Appendix J – Road Safety Audit Designers Response

Title: 23161 TN13 Road Safety Audit designers' response – 1st Issue

1.2 The purpose of this report is to provide a Designer's Response (DR) to the Stage 1 Road Safety Audit (RSA) carried out by 'J Bartlett Consulting Ltd' in May 2025. This Stage 1 RSA related to the access proposals associated with the two development sites.

PROJECT REF:
23161
DRAWING No:
032

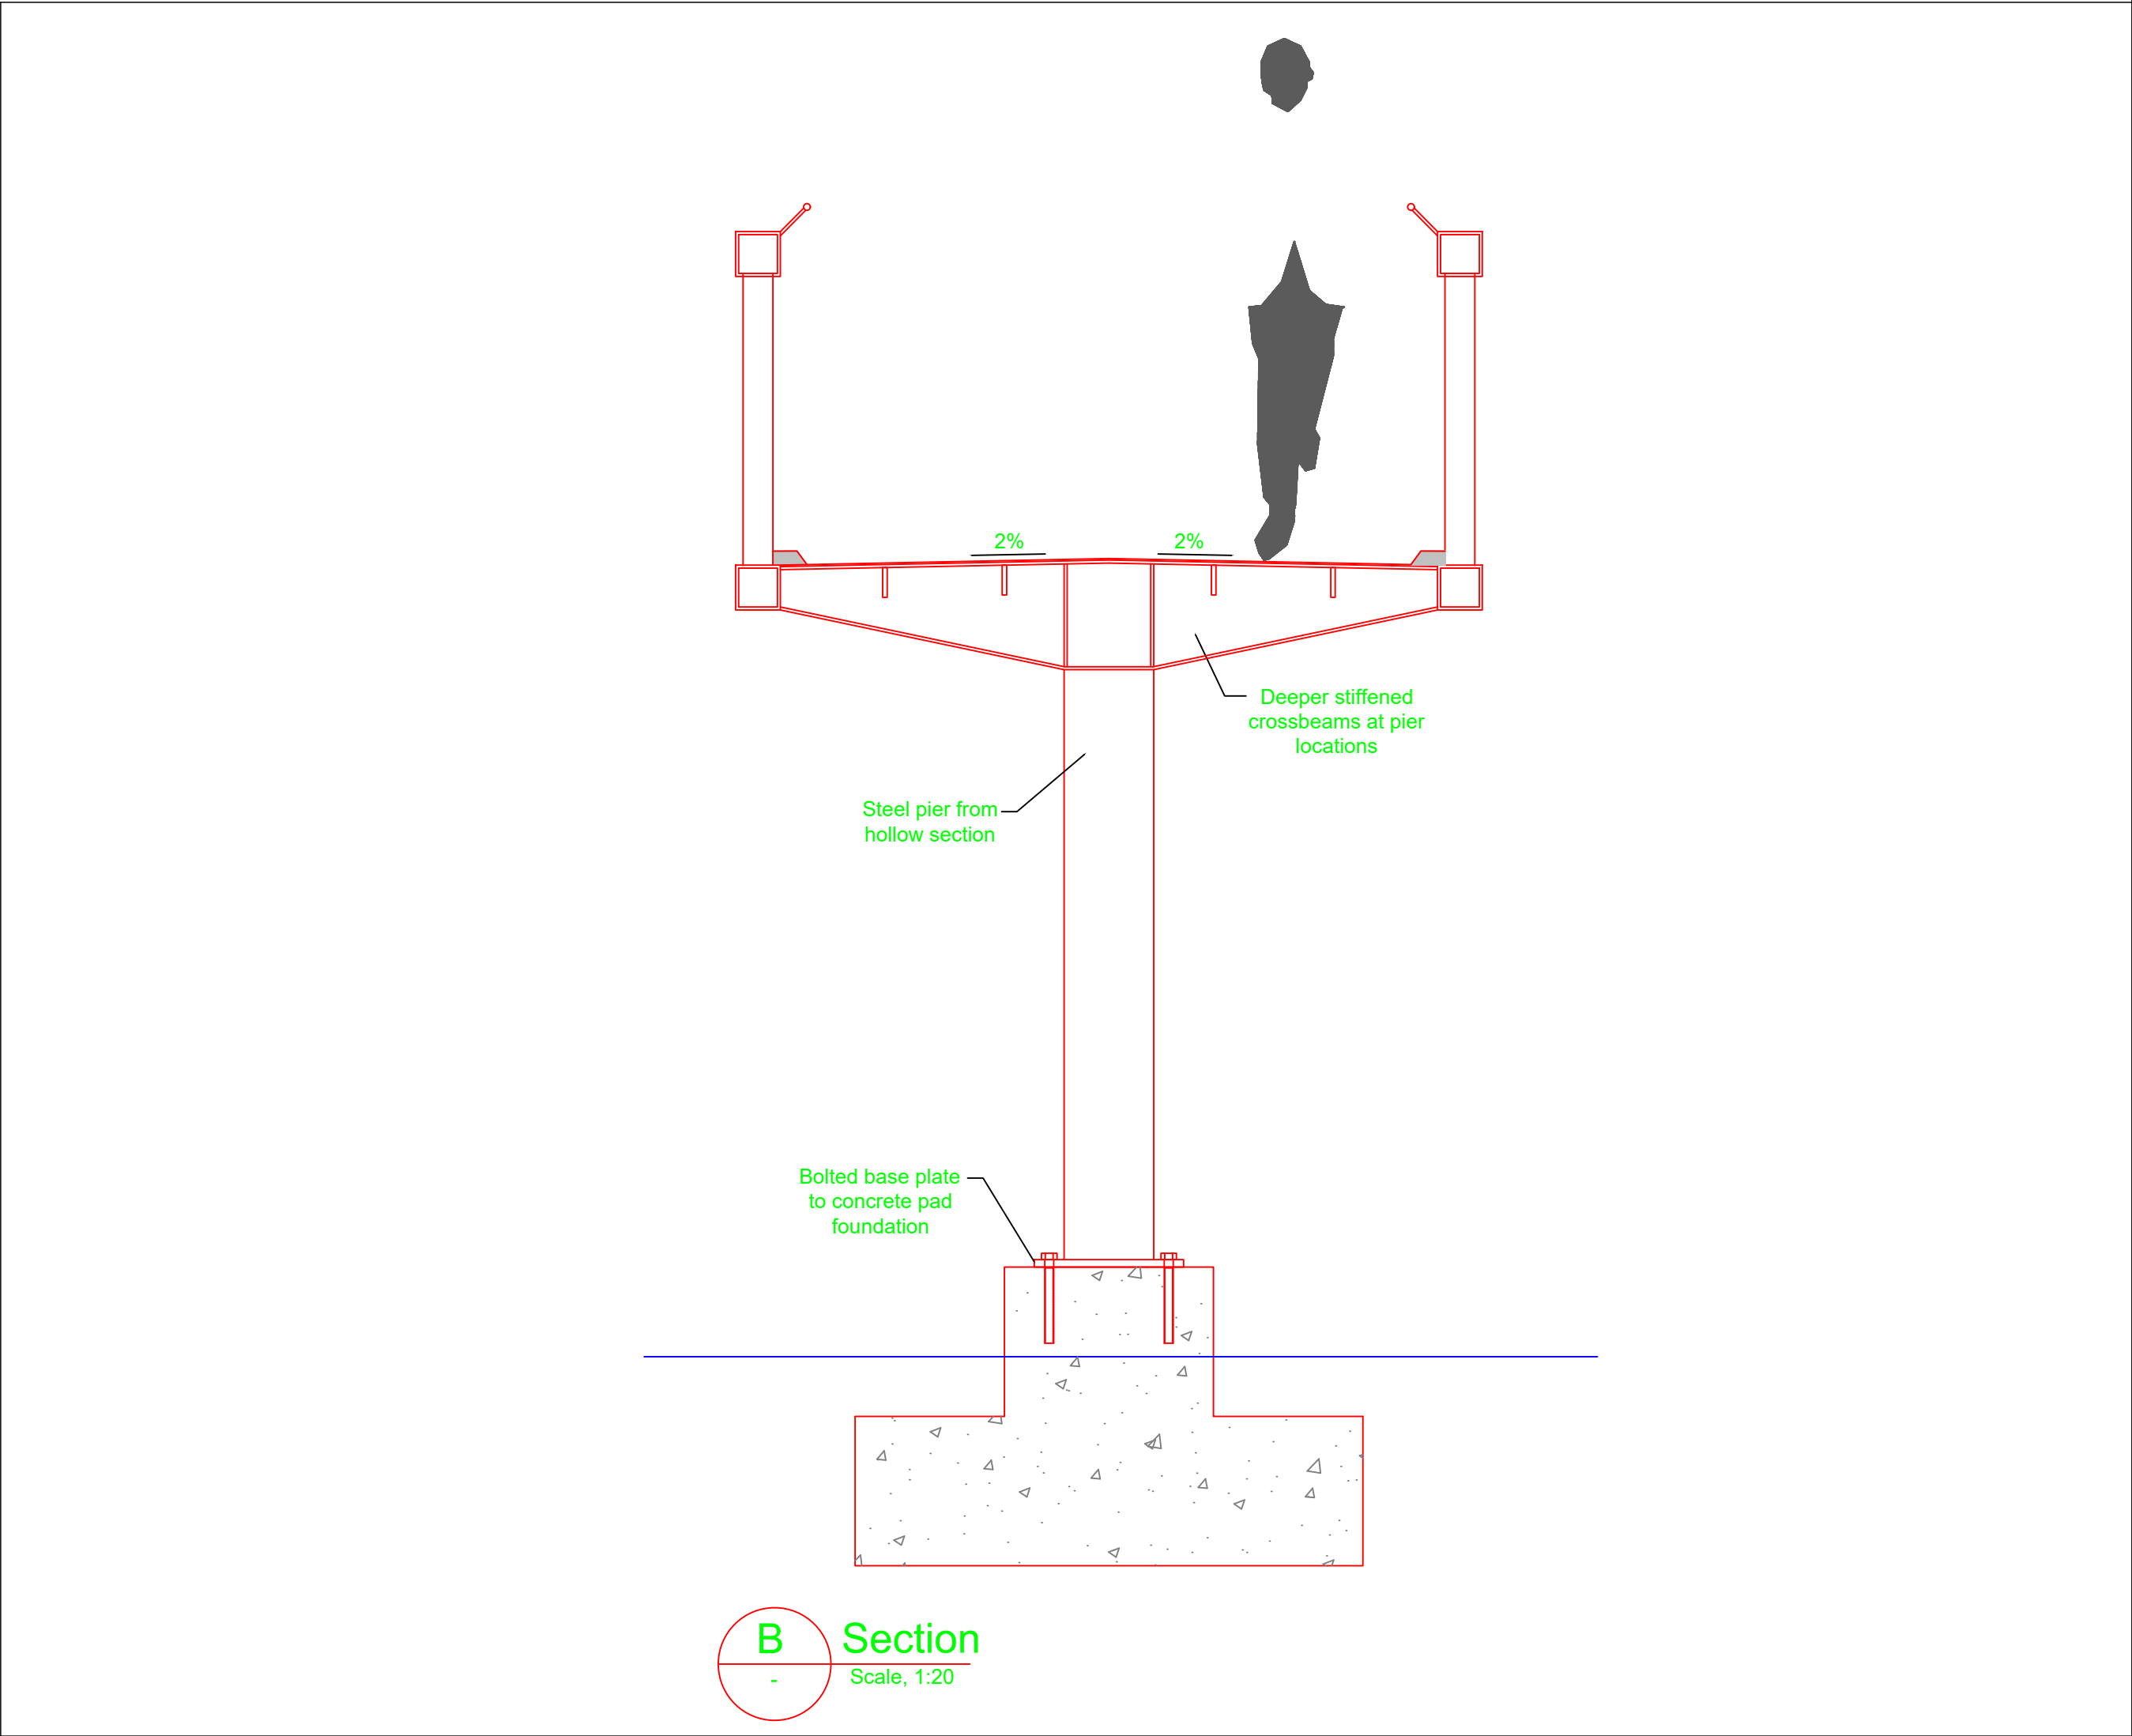
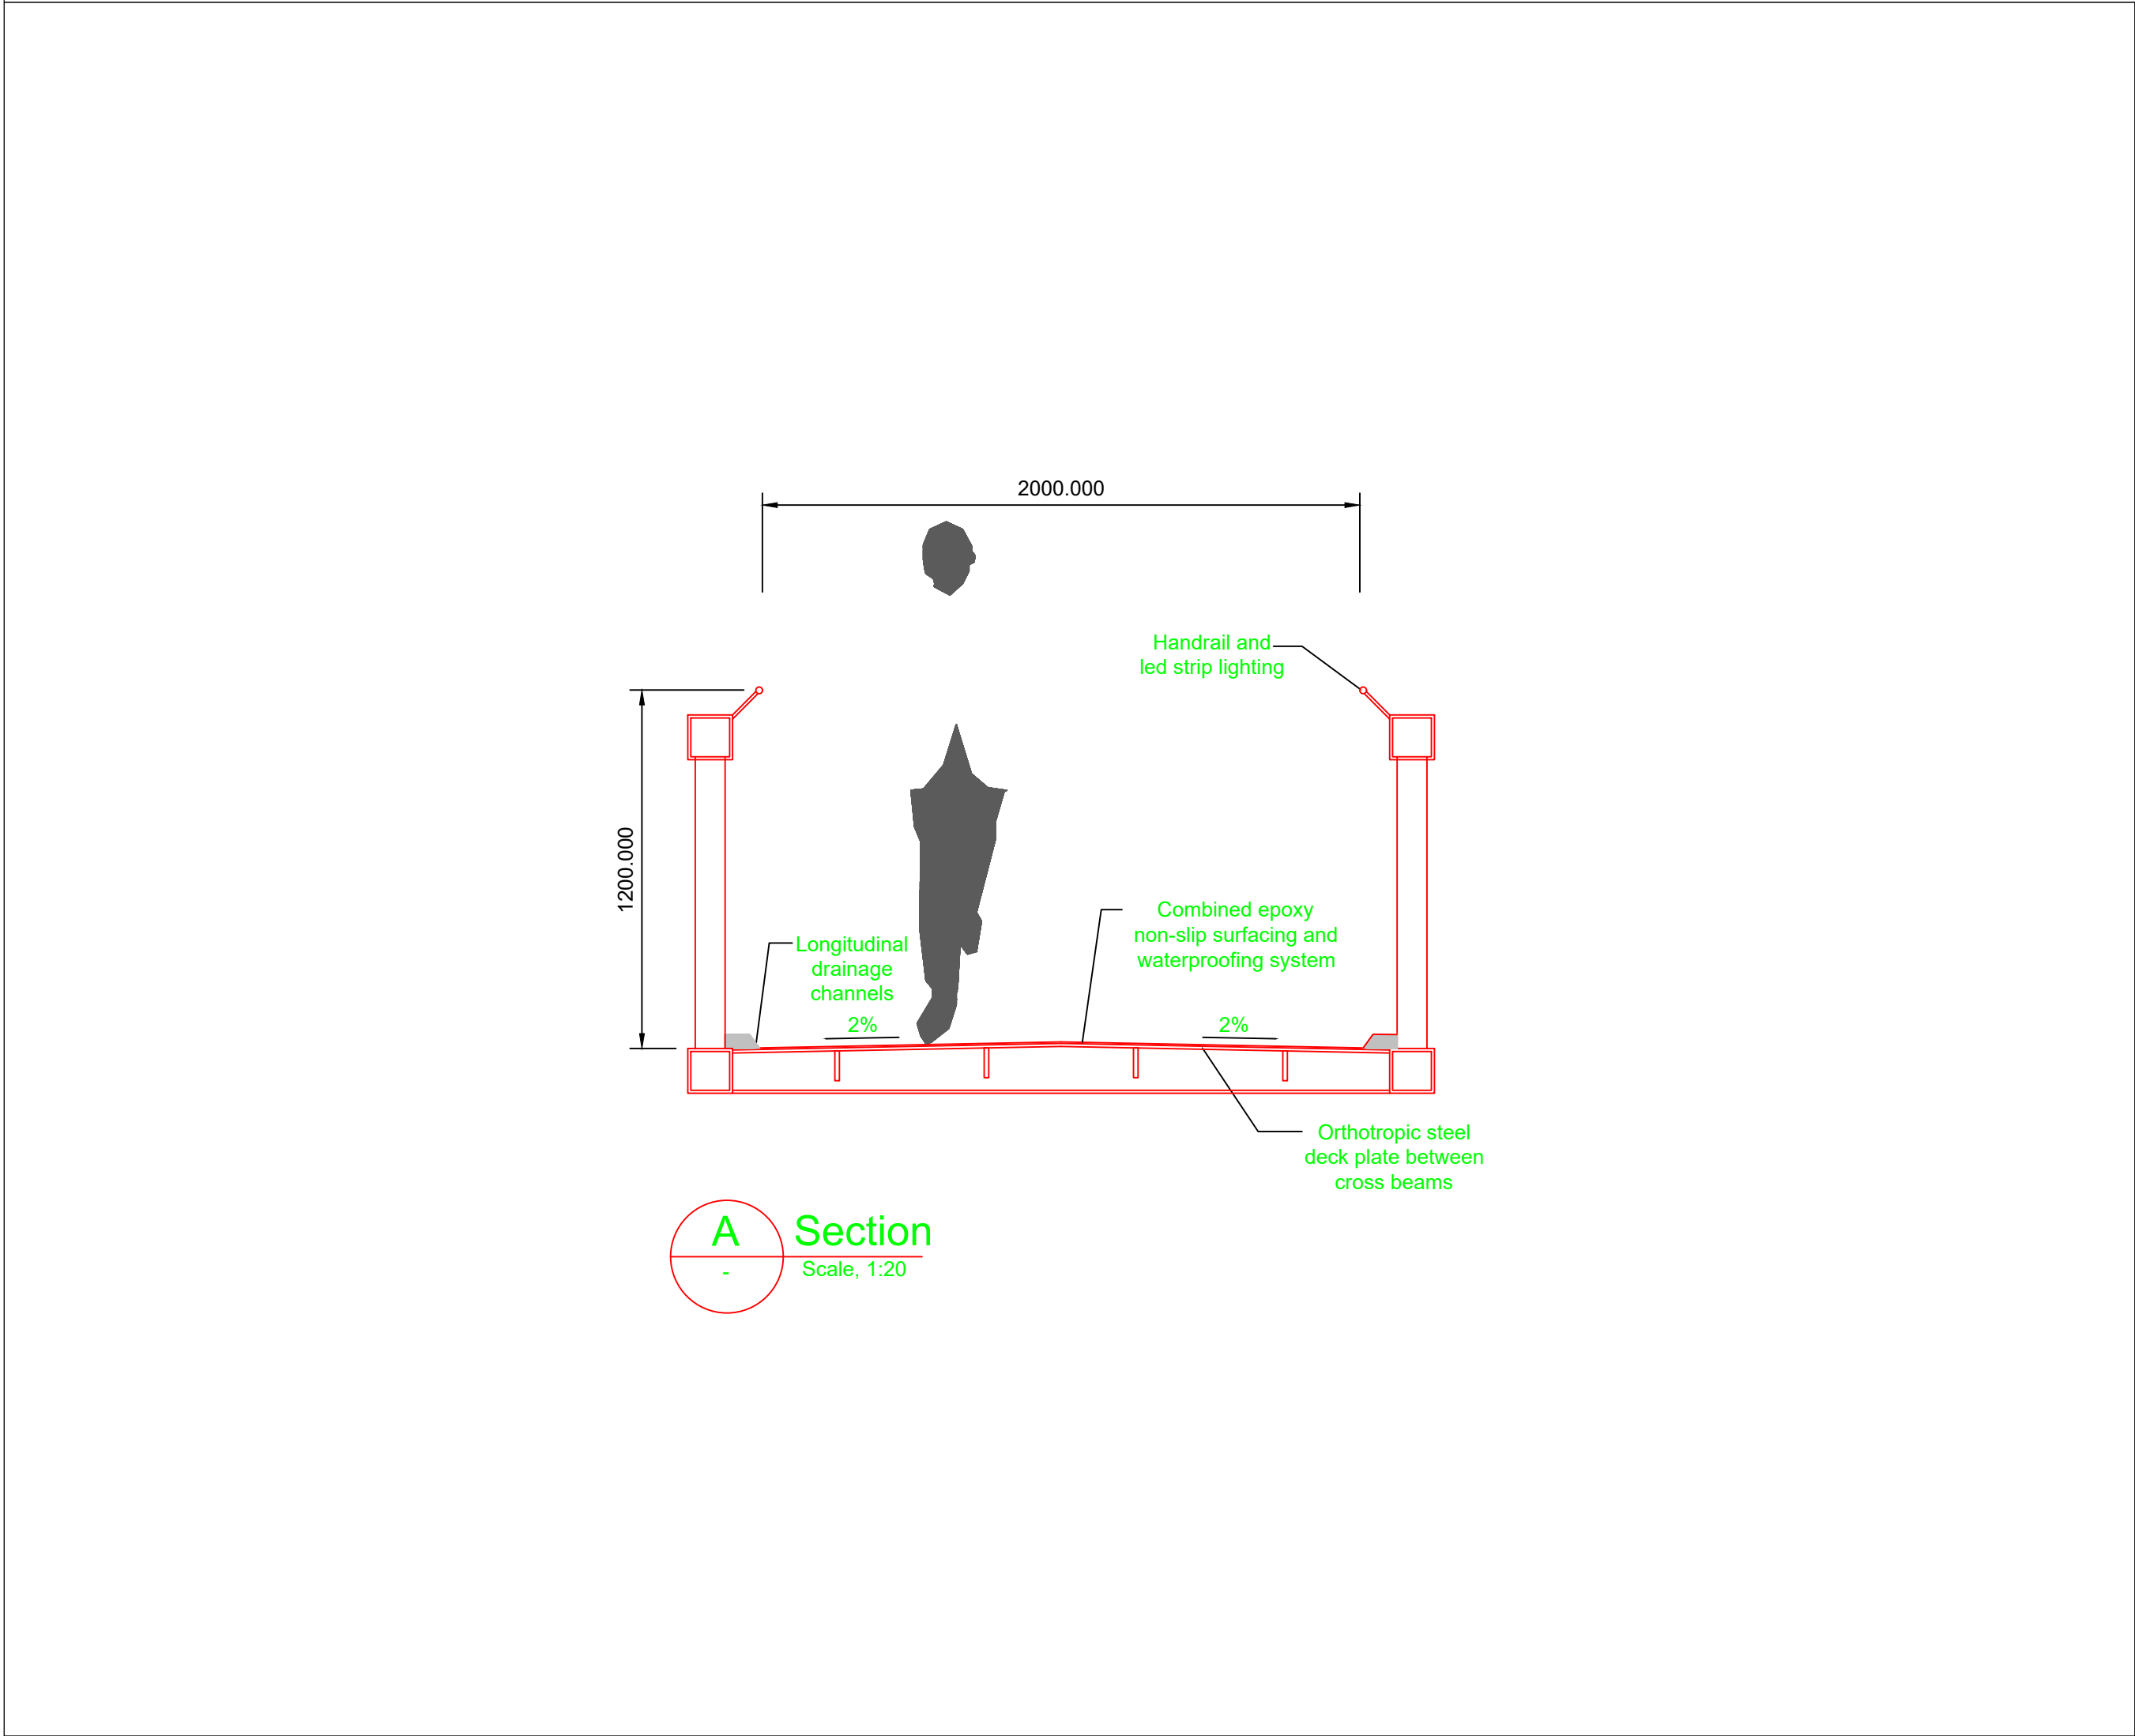
"The highway authority has requested that the introduction of a Toucan Crossing for the southbound approach to the Baldock Road roundabout junction be considered in terms of safe operation. The audit team's observations are listed below, all carrying equal significance and are in no particular order."

- *There is no indication of the likely usage of the crossing and there are concerns that where crossing are not used the 'constant' green to drivers can be overlooked if it changes to red as local drivers become over familiar with the road layout. The audit team are also aware of situations where crossings of this type revert to red and / or change to red depending on approach speed and traffic volumes, some of which are time dependant, to manage vehicle speeds on the approach to the junction and prevent the "constant" green effect. These elements, however can only be considered as the detailed design progresses;*

- *There is the potential for drivers approaching from the north in particular those unfamiliar with the area, to assume that the roundabout is signal controlled and that they have right of way leading to the potential for failure to conform type collisions; however the audit team accept that the scheme is at preliminary design and the finer detail of the provision has not been addressed.*

recognise the nature of the control should be addressed as the scheme develops and appropriate signing should be provided on all approaches to warn drivers of the controlled crossing ahead. It may also be beneficial to include count down type markers for the change in speed limit and position it further to the north to allow segregation of the speed limit change from the crossing and allow for speeds to reduce on the approach to the roundabout.
